SUBJECT: Case 17443: Clayton Developments, Rezoning of Colby South, Phase II

INFORMATION REPORT

SUBJECT: Case 17394, Colby South Phase II Rezoning, Cole Harbour

COLBY SOUTH MASTER STORMWATER MANAGEMENT PLAN

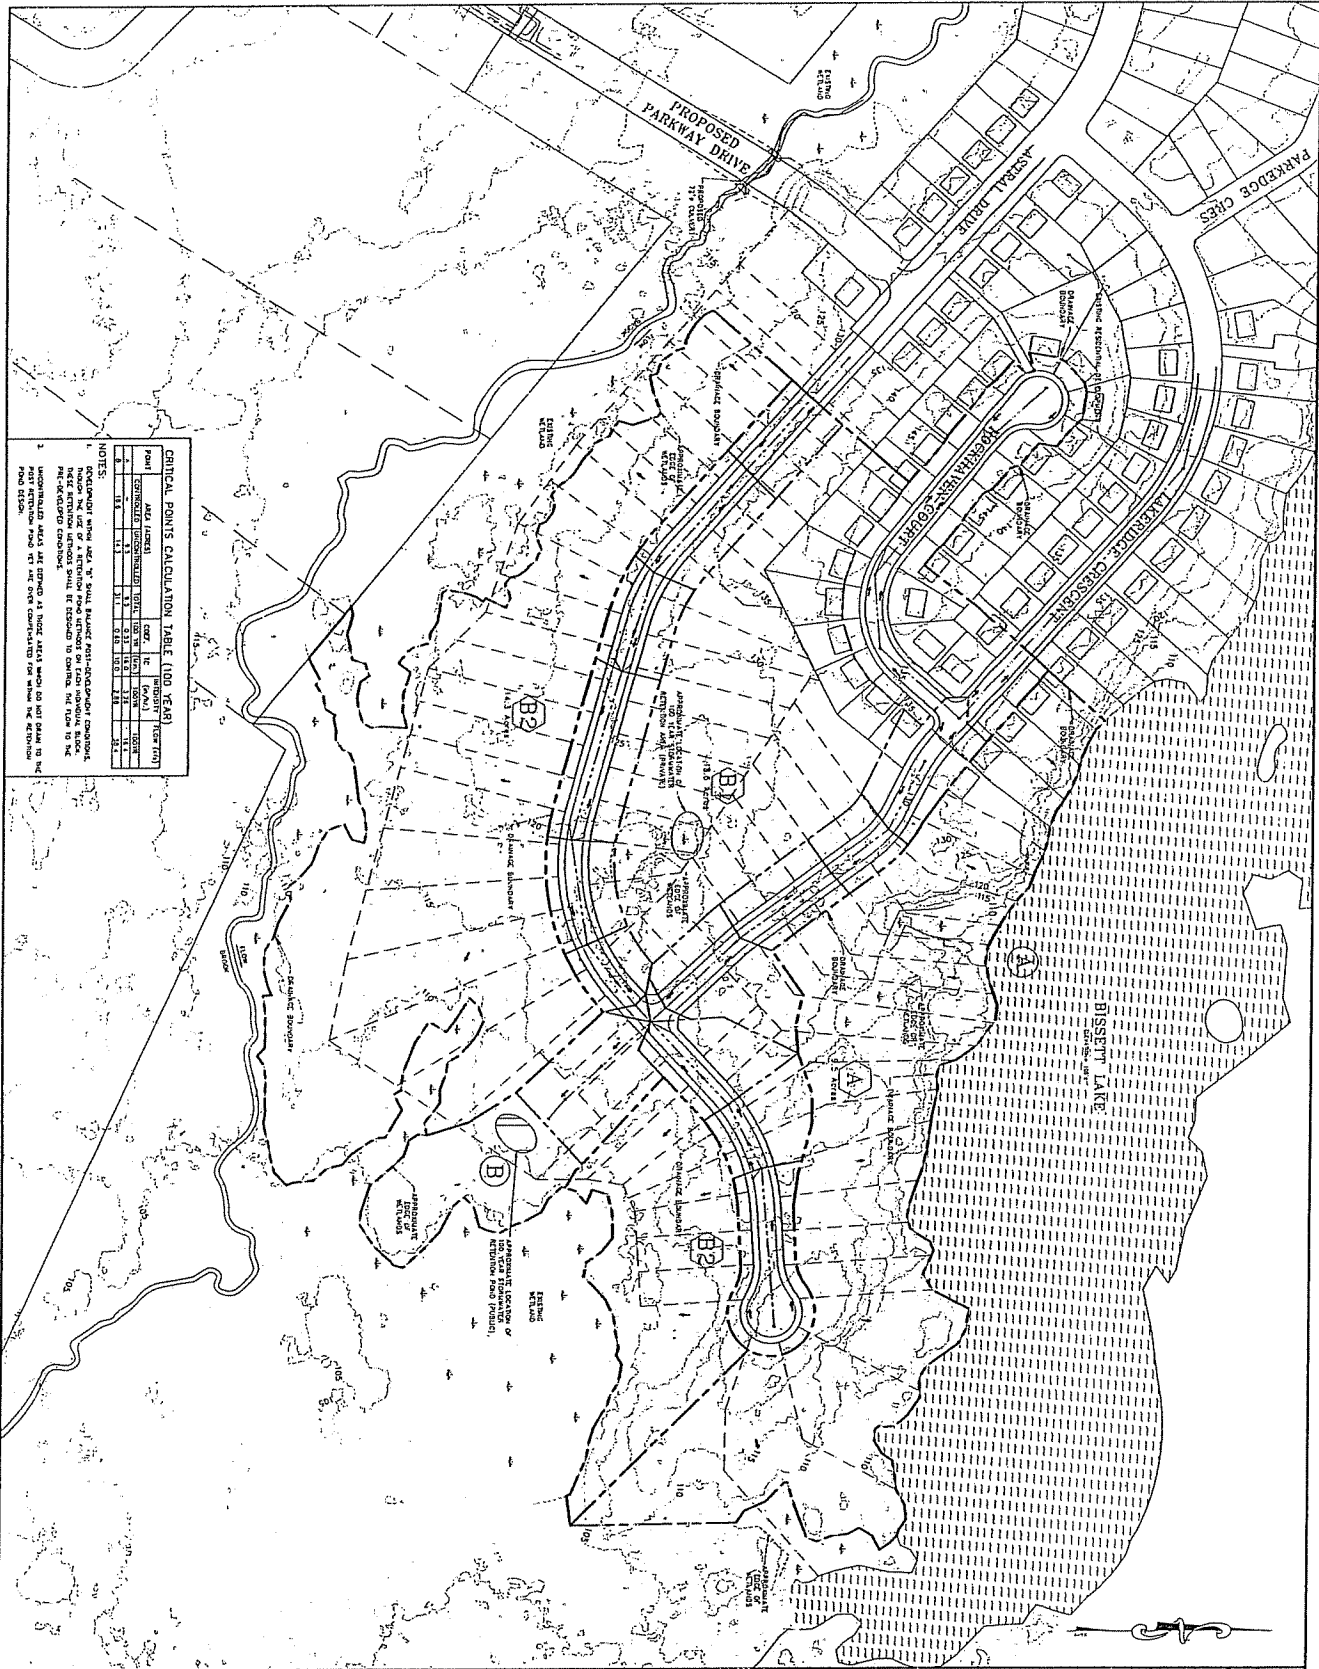
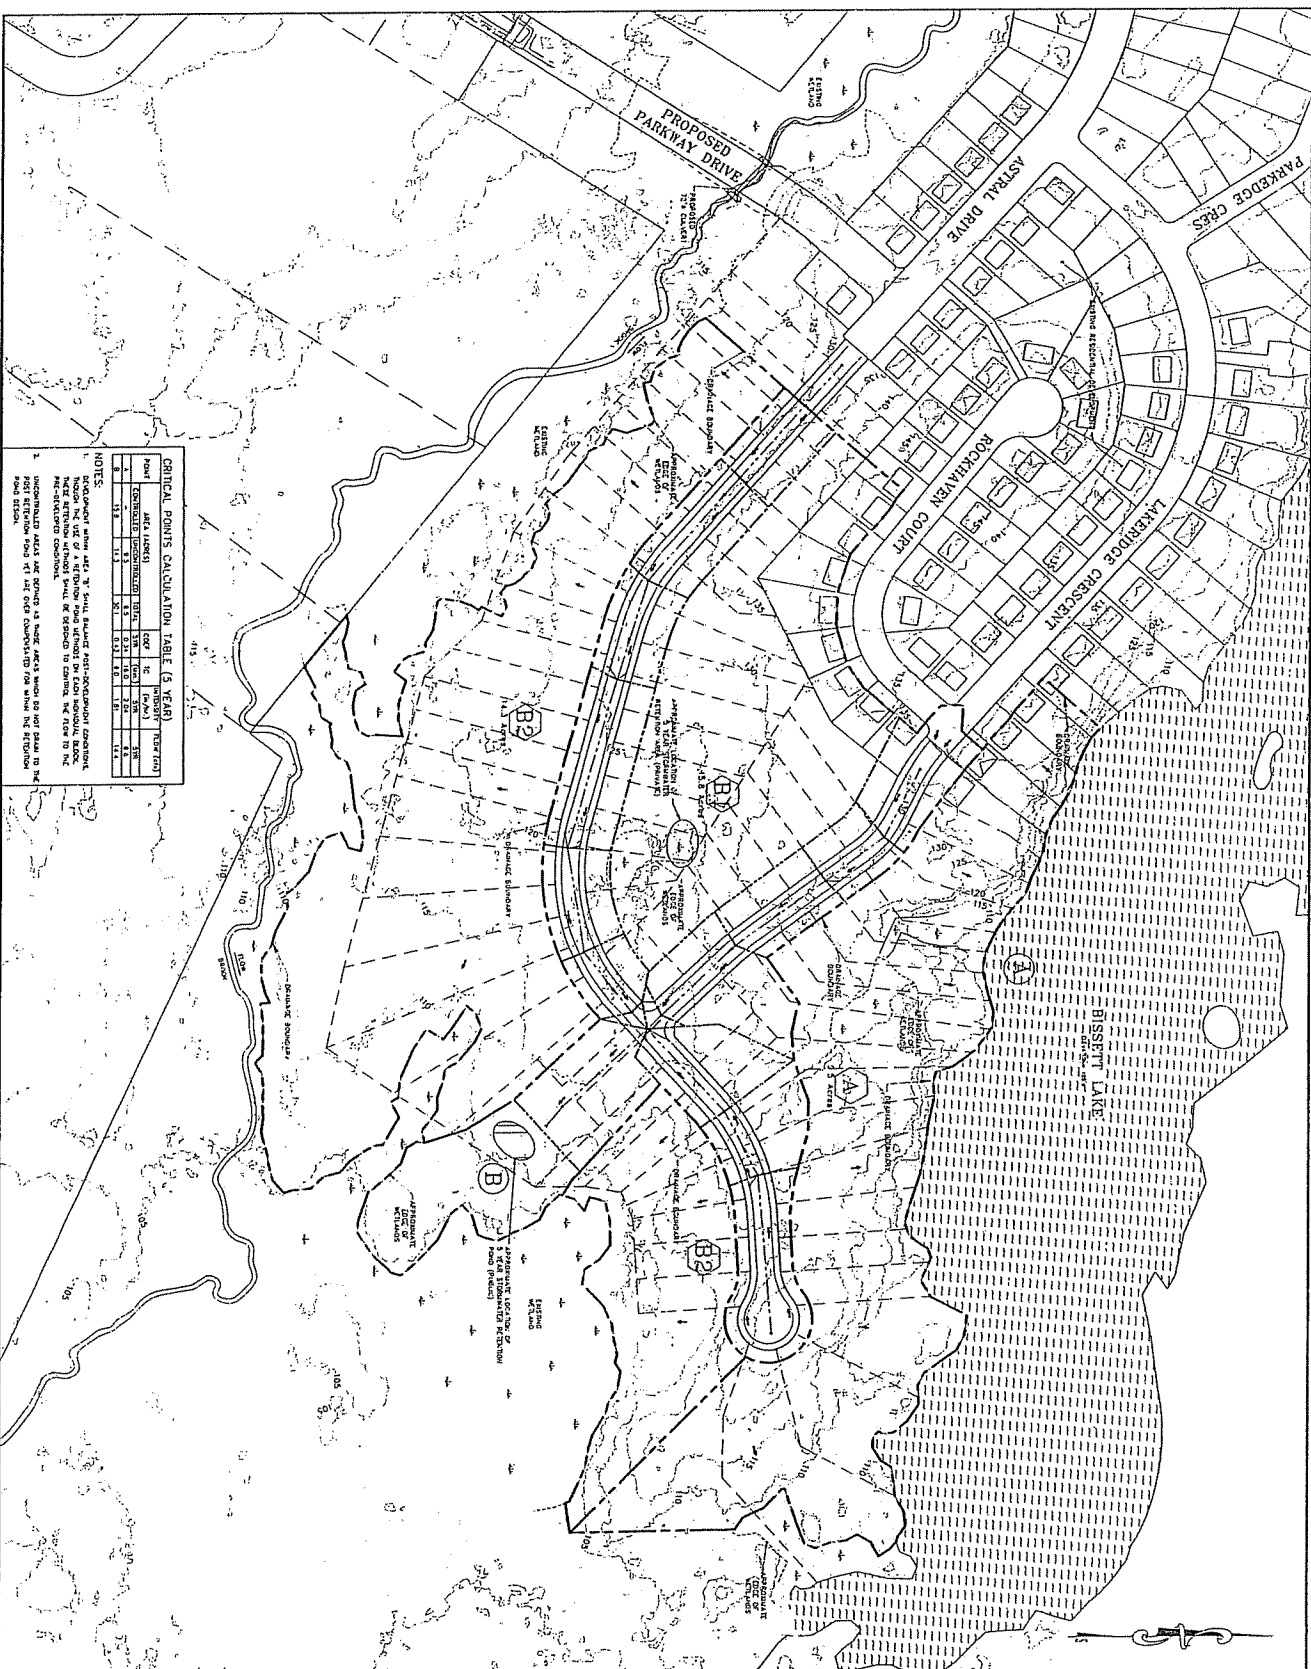
The Board reviewed the proposed Stormwater Management Plans for pre and post development and staff and the developer responded to questions related to the water quality affects on Bissett Lake from Phase I.

Clayton Development Limited had advised that they would be looking to balance pre and post stormwater to ensure that any existing wetlands being impacted would not be further impacted long term. Clayton Developments Limited has submitted an alteration proposal to the Nova Scotia Department of the Environment for Parkway Road and another small road in the core of the development that is not tied to any water courses. The overall water quality will be improved based on the stormwater management facility they are proposing.
